ADDENDUM NO. 1

WASHINGTON STATE PARKS AND RECREATION COMMISSION
WALLACE FALLS STATE PARK
WELL DRILLING CONSTRUCTION, DEVELOPMENT, AND TESTING
NW-C4002

DATE: February 21, 2025

SITE PLAN - AREA A

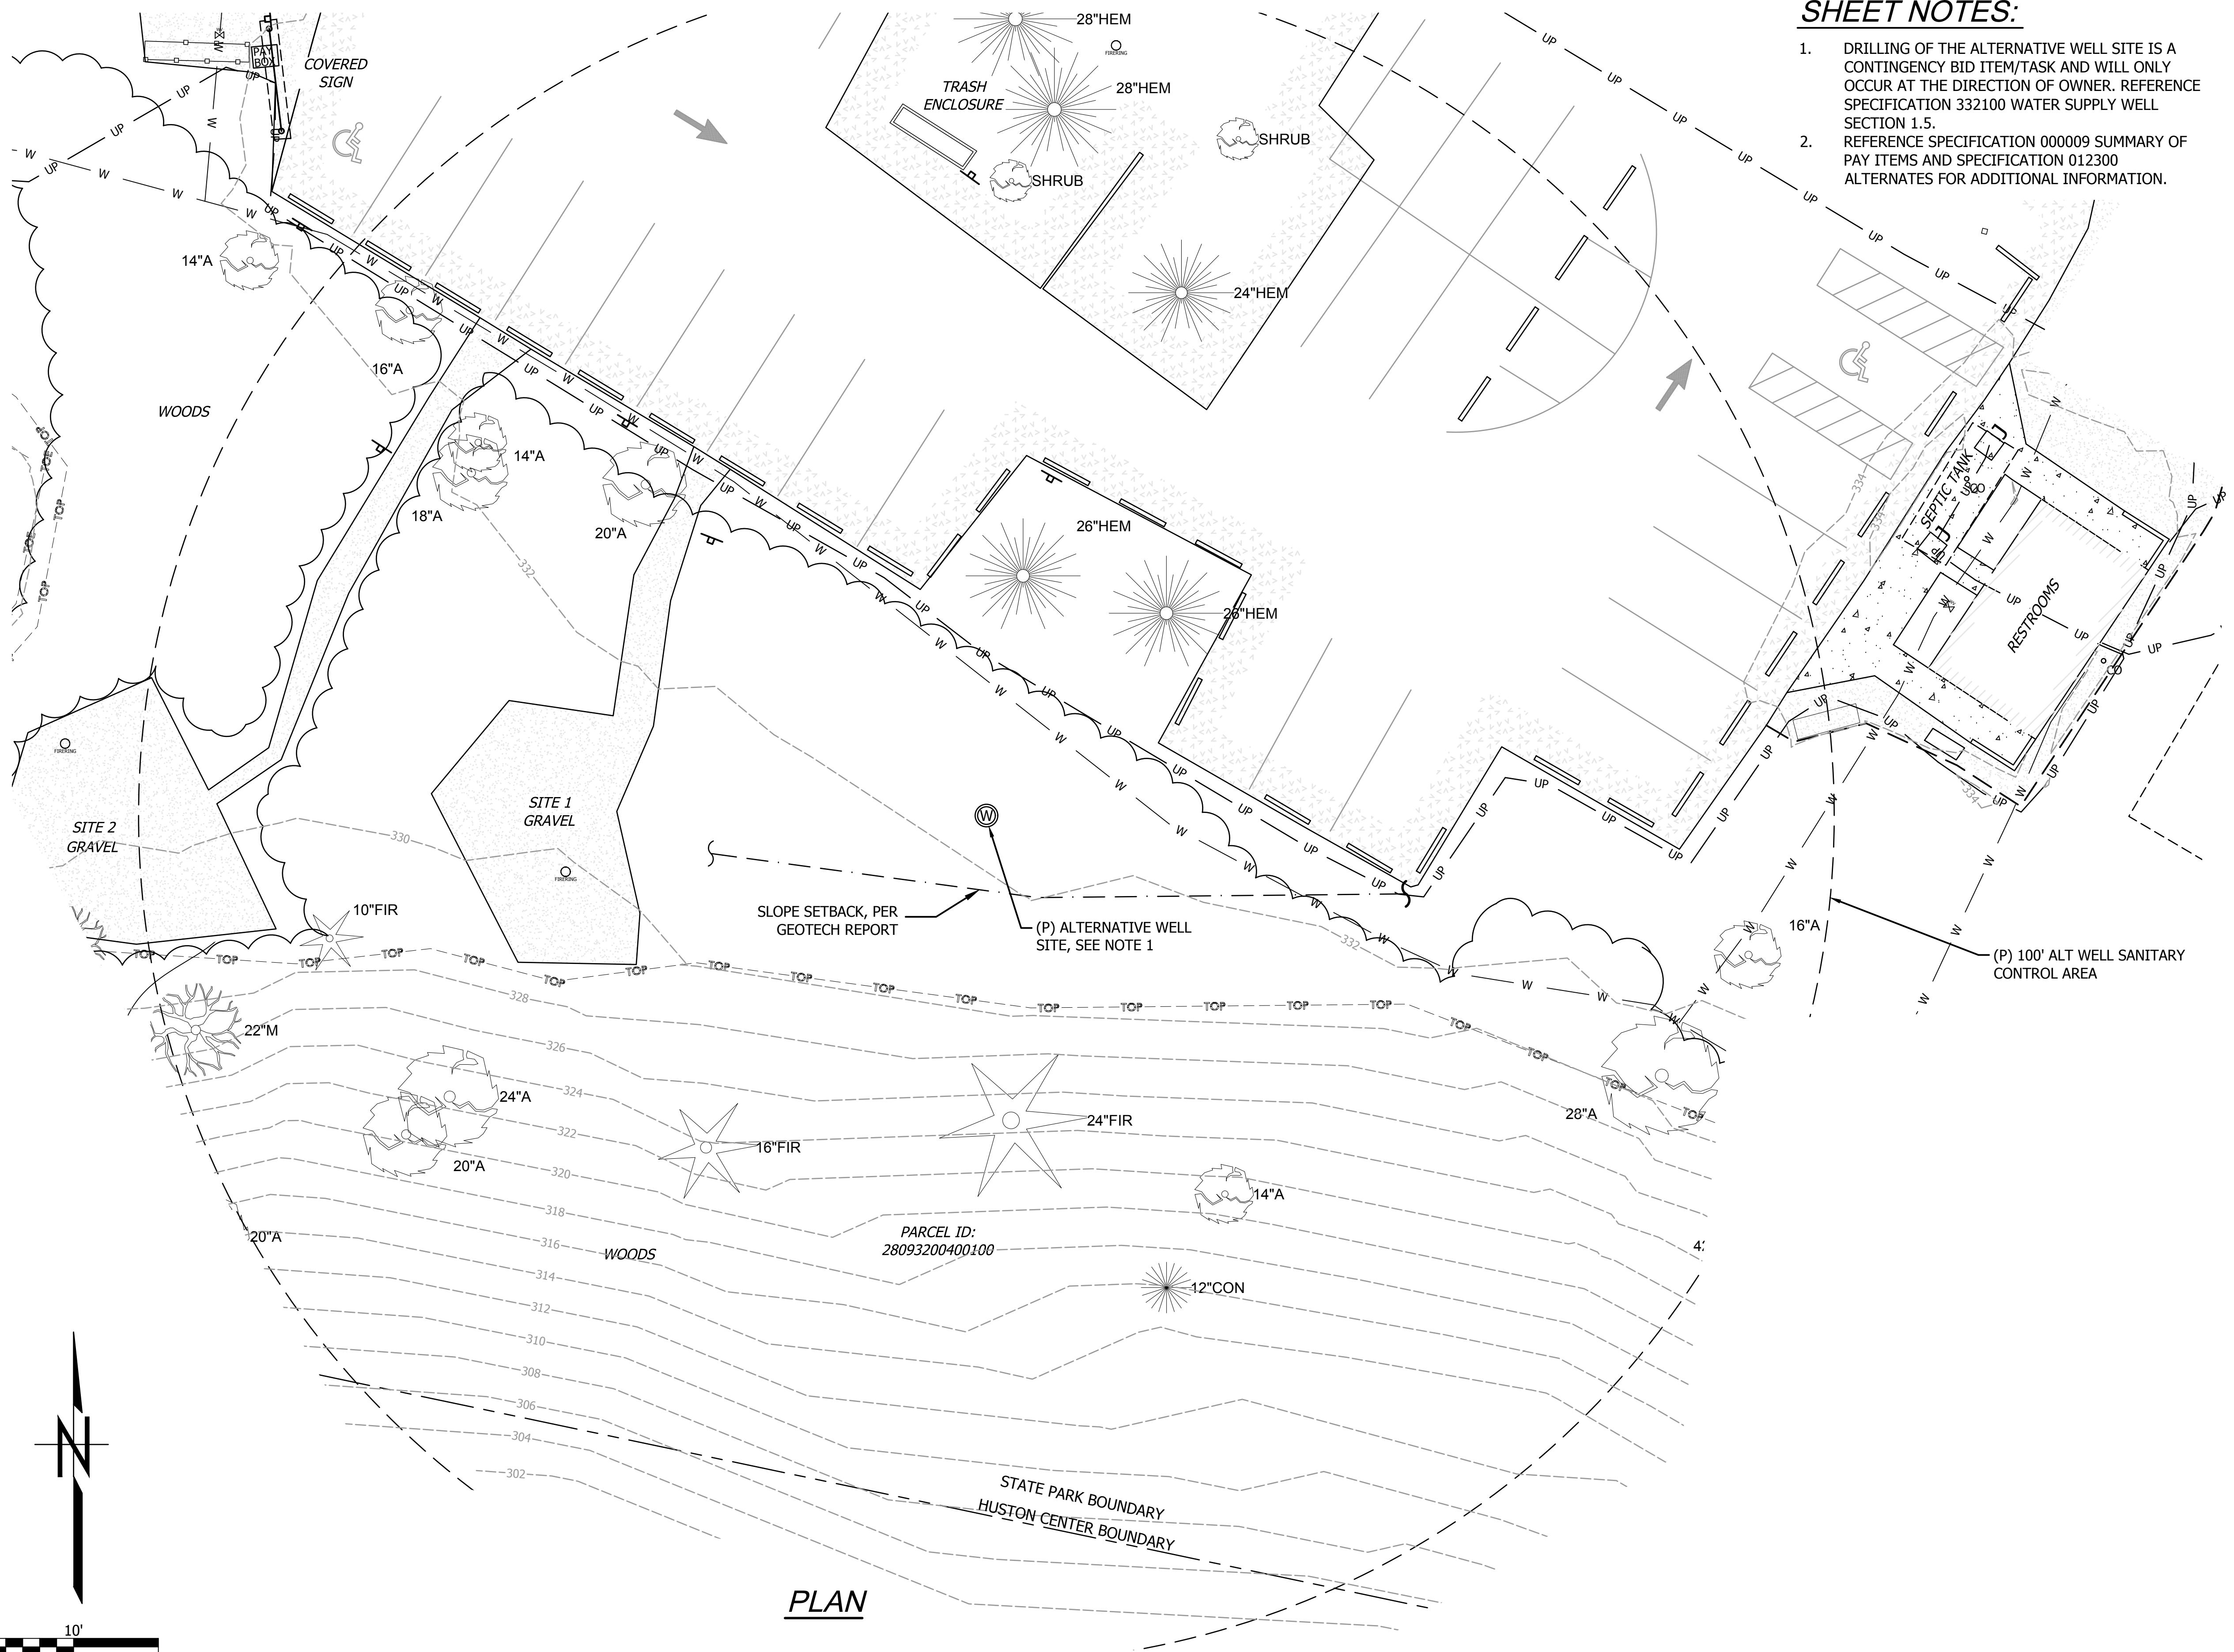
- 1) Sheet C201 Overall Site Plan:
 - a. There is an 18" Alder near the location of the base bid proposed well. See attached Revised Sheet C201. This tree may be removed for construction.
- 2) There was an error uploading the drawings to the MRSC Bonfire Procurement Portal; the signed drawings have been included as part of this addendum.
